**Final Work Plan
Bedrock Groundwater Study
At Landfill 6, Building 775, AOC 9, and
Building 817/WSA**

**Former Griffiss Air Force Base
Rome, New York**

USEPA Comments and Responses to the November 19, 2001 Bedrock Groundwater Study Proposal

NYSDEC Comments and Responses to the November 19, 2001 Bedrock Groundwater Study Proposal

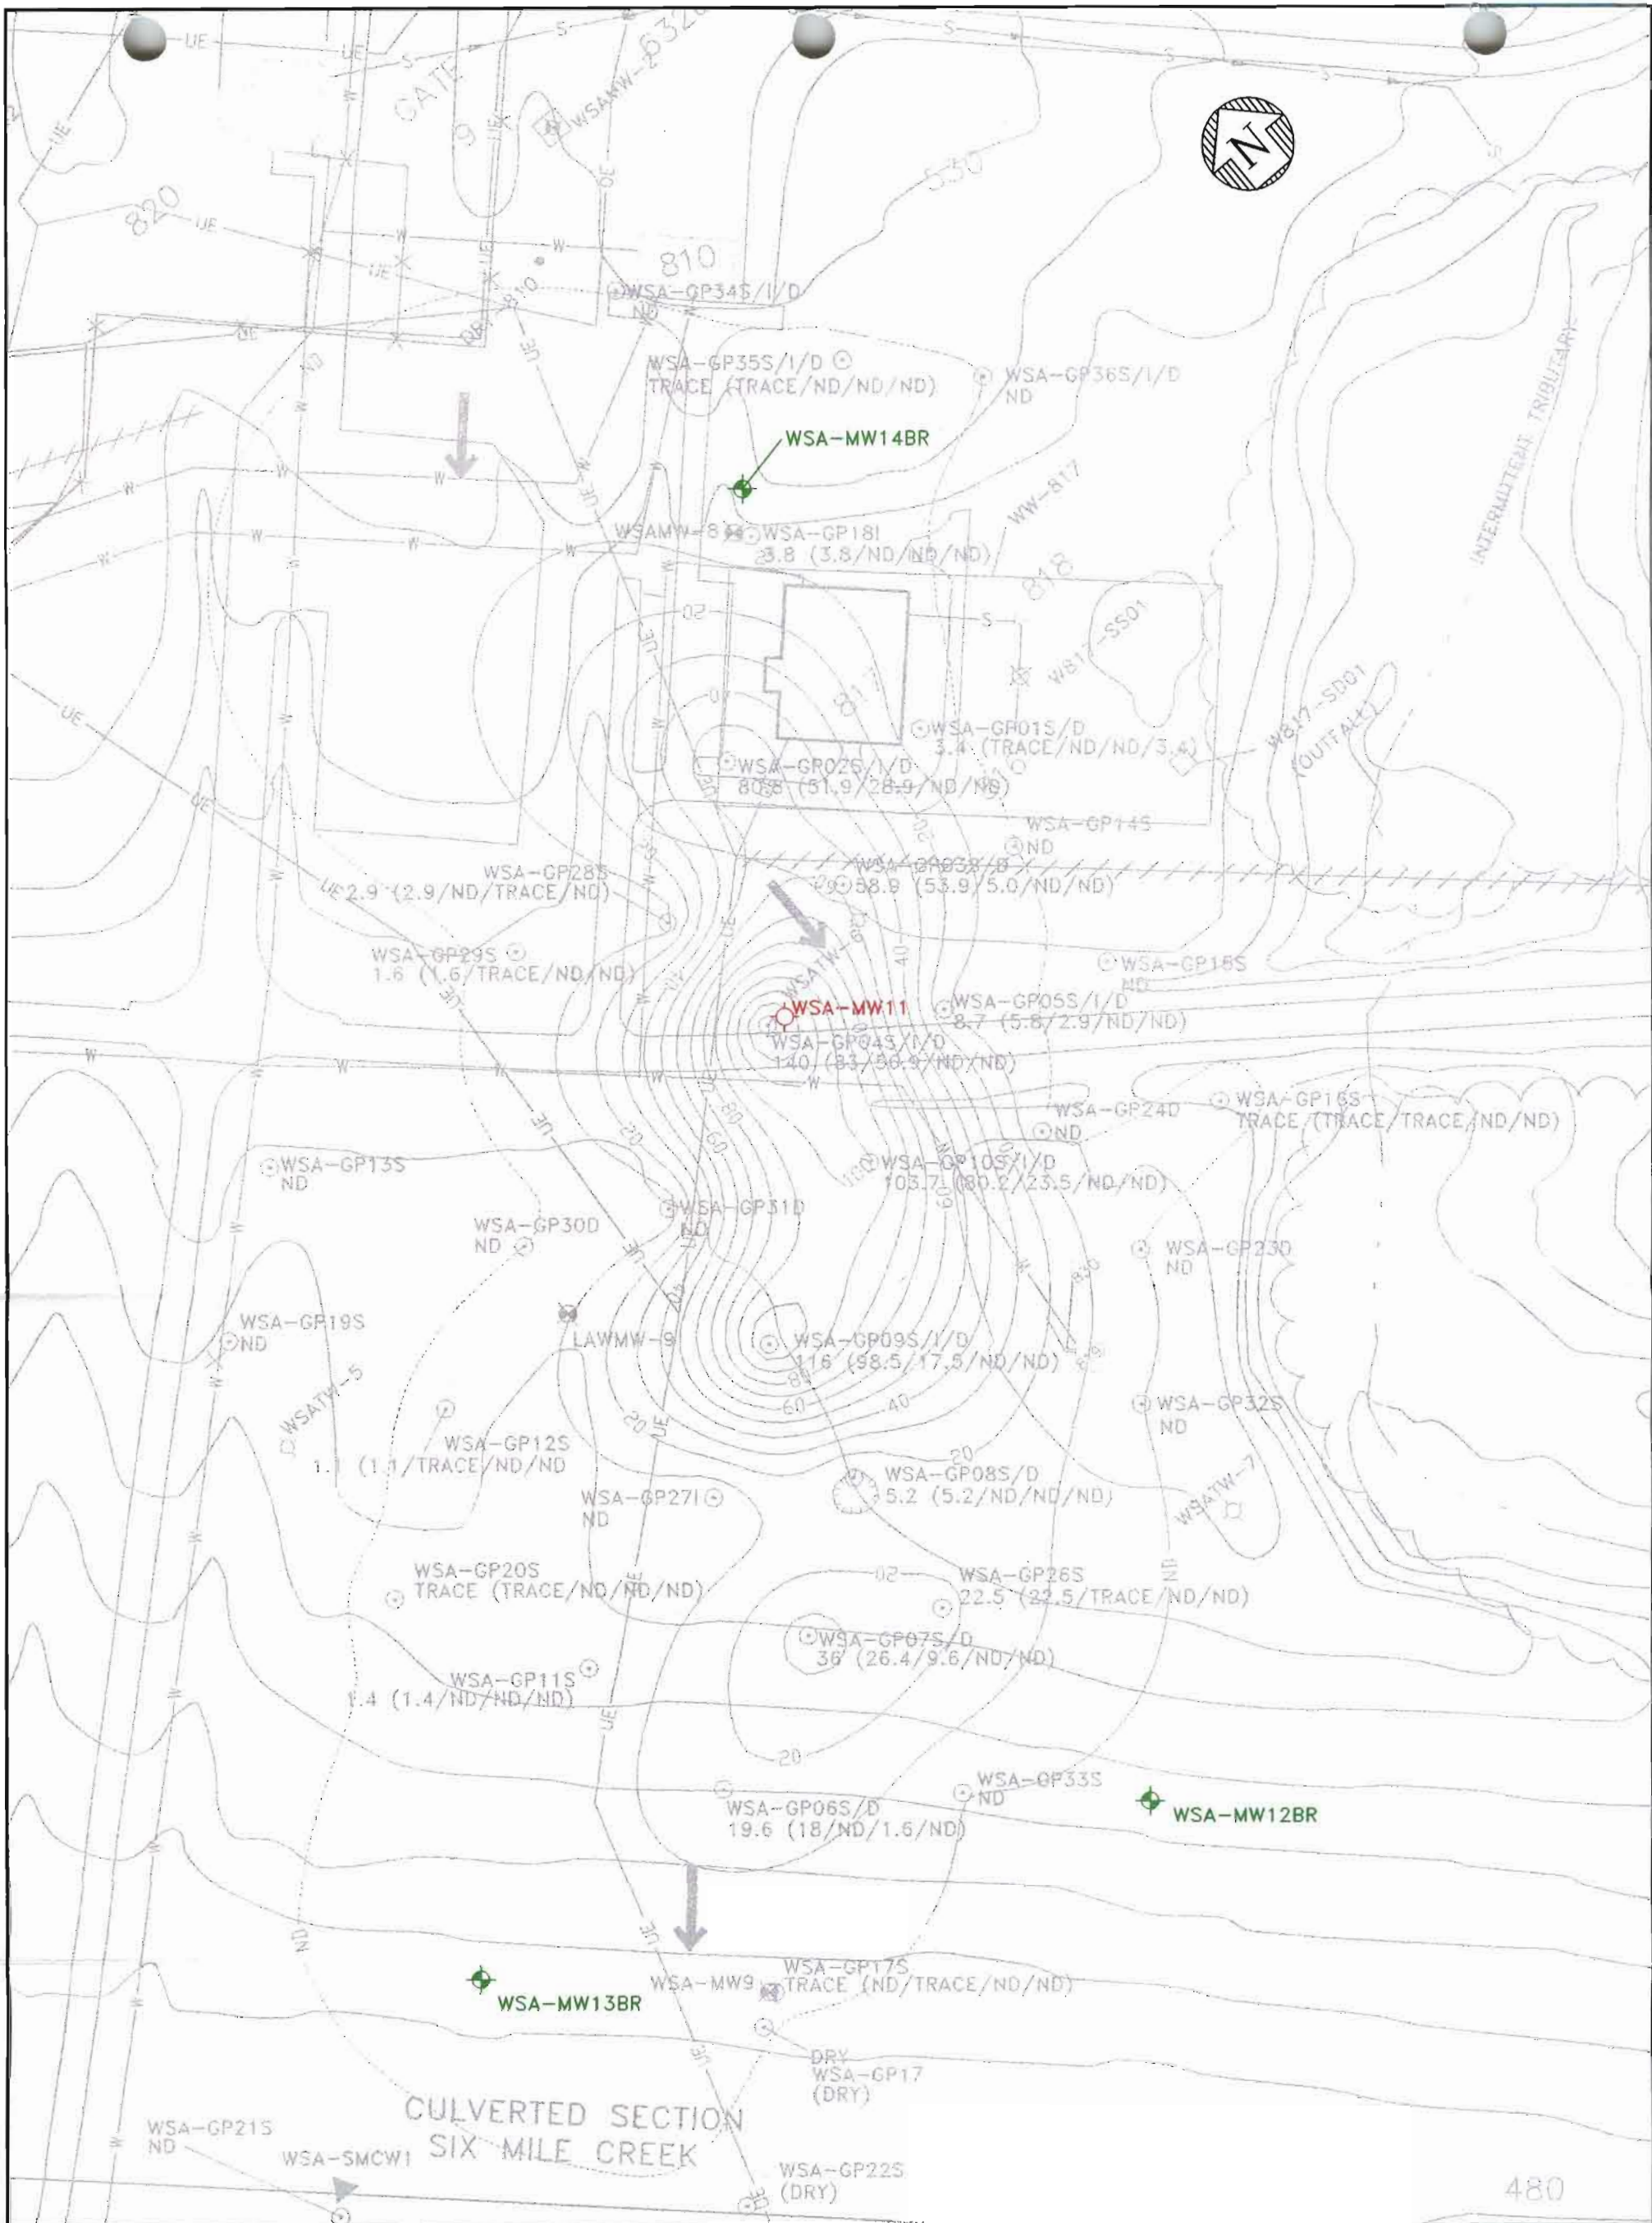
4. **Comment:** *Figure 4 (Figure 2-4 in the work plan) indicates 1 "upgradient" and 2 "downgradient" monitoring wells. I am under the assumption that the well identified as WSA-MW2D on Figure 4, is actually proposed well WSAMW-12D on page 5 of the text. Overall, the proposed locations appear acceptable, with caution. At AOC9 and AOC - south of WSA, the distances between upgradient and downgradient as well as from the concentrated areas of the unconsolidated formation plumes is possibly too large to enable the three points to be used for flow direction analyses with any reliability. I will need to have a better explanation as*

to why these downgradient locations were selected and whether locations closer to the unconsolidated plume might be more beneficial.

Response: Yes, WSA-MW2D should have been WSA-MW-12D, however, although the well locations are the same, they have been given a new nomenclature in the work plan. The reason the distance between the upgradient and downgradient wells is due to the elongated nature of the plumes at these sites. The three points at each site should be ok to be used for determining the direction of groundwater flow.

Figure 3-1 PROPOSED CONSTRUCTION FOR OPEN-HOLE BEDROCK MONITORING WELLS

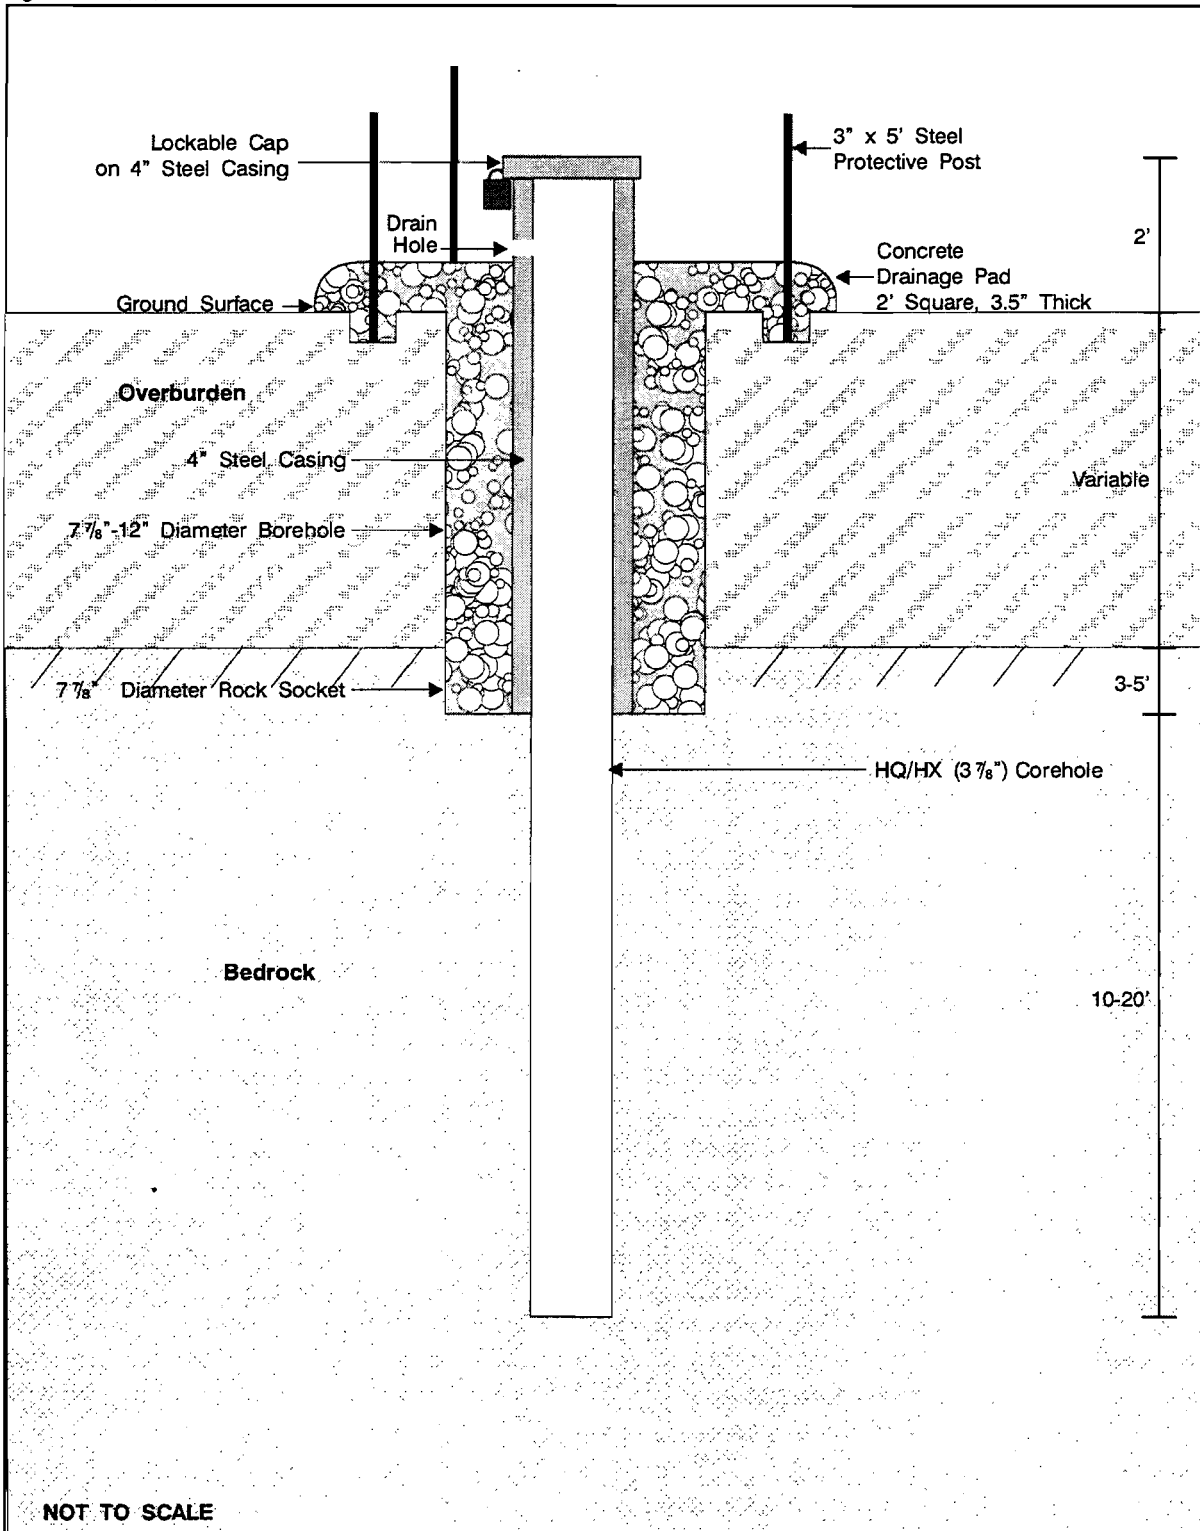
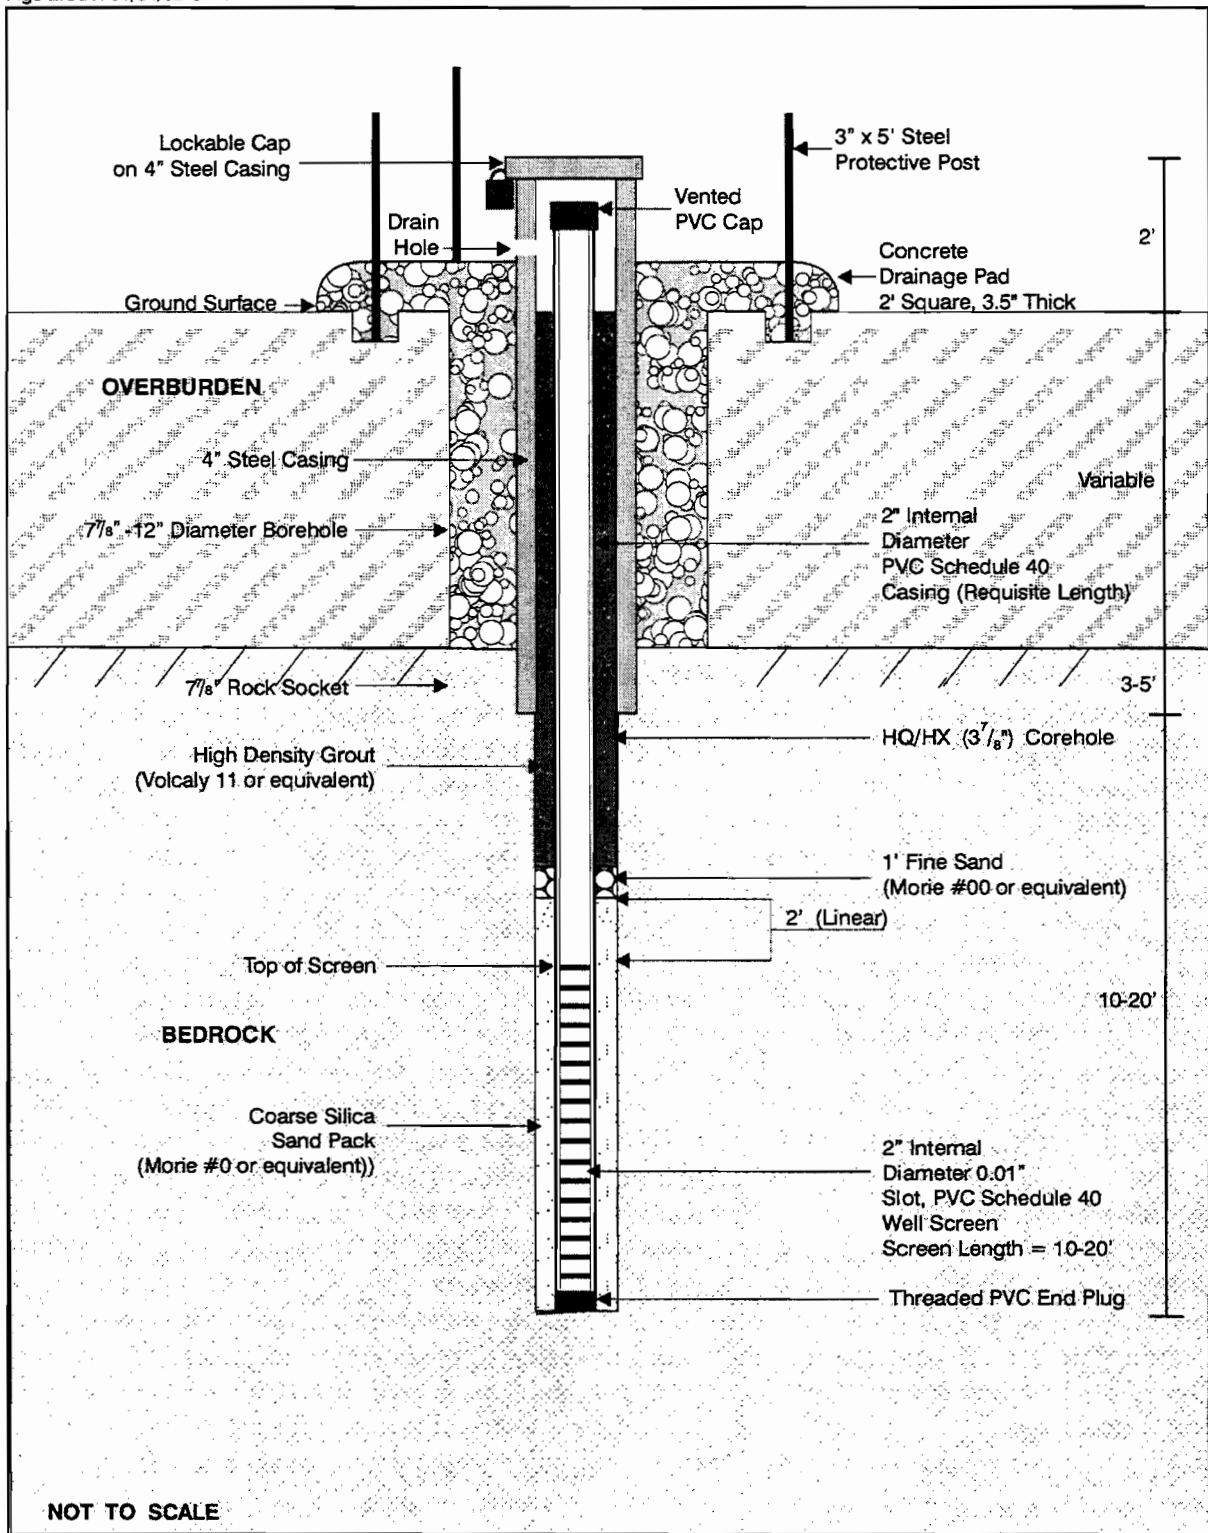
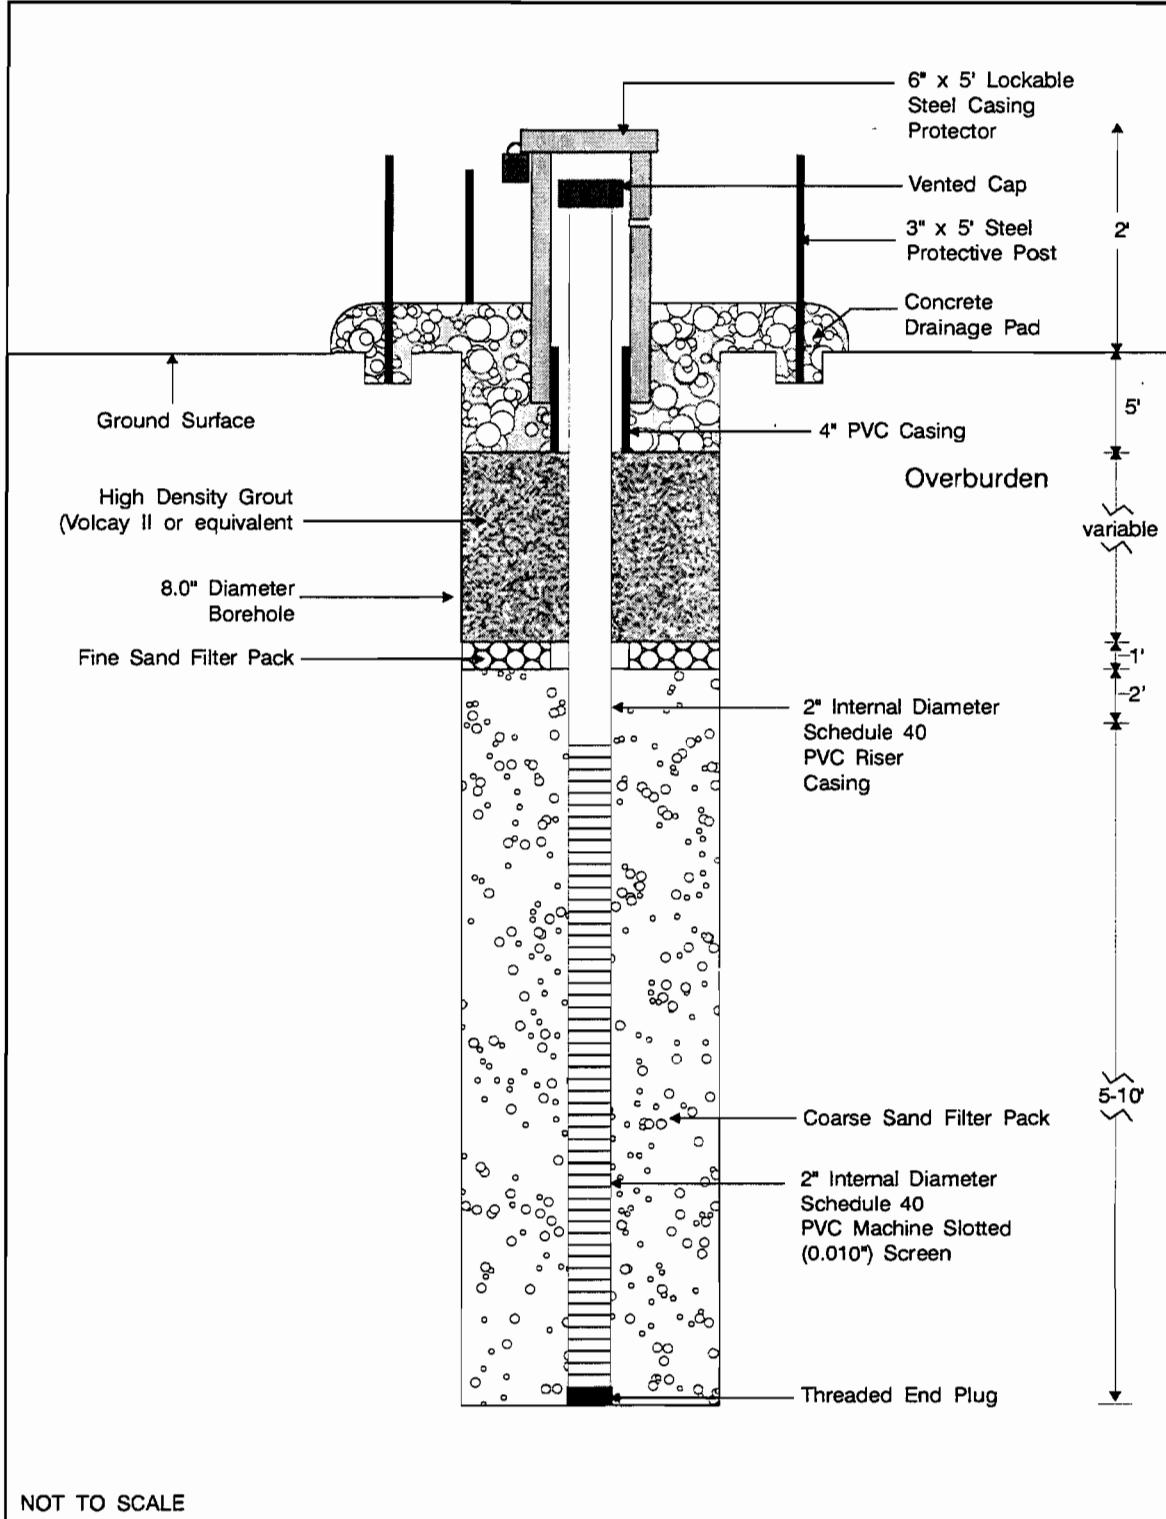
4. **Comment:** A few drawings of the proposed wells would be nice (e.g., show the casing diameter, auger size, core size, thickness of bentonite seal at the interface, etc.).

Response: The November 19, 2001 document was not intended to be a work plan. The work plan for this investigation will include well construction diagrams, as well as all the necessary procedures.
